80960HA/HD/HT

Specification Update

April 1998

Order Number: [272830-005](#)

Figure 59. BREQ and BSTALL Operation

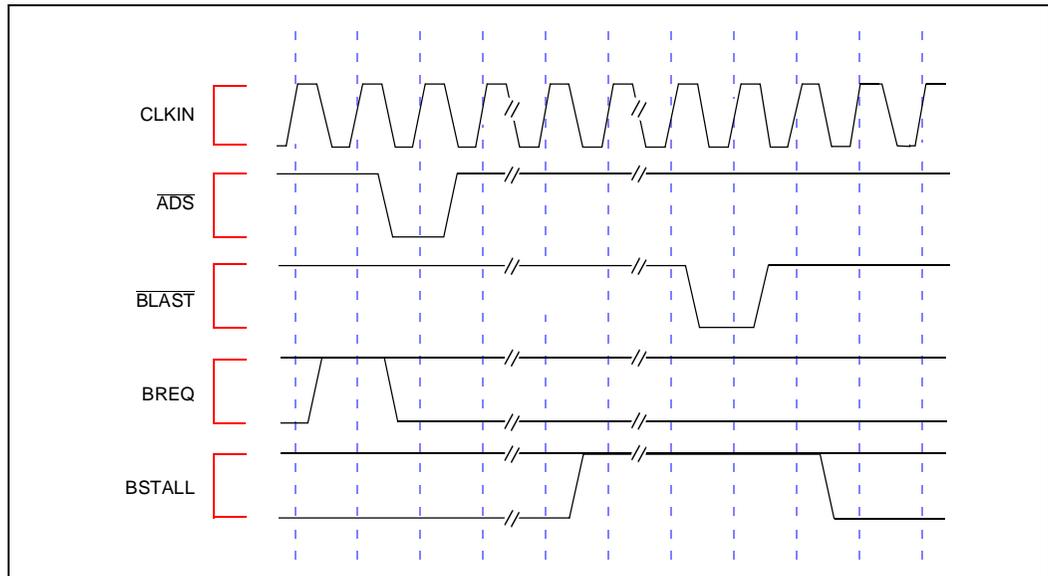
Affected Docs: The *80960HA/HD/HT 32-Bit High-Performance Superscalar Processor* datasheet, August 1997, release 006 and all earlier releases.

FROM/TO REFERENCE: Add Figure 59, as shown:
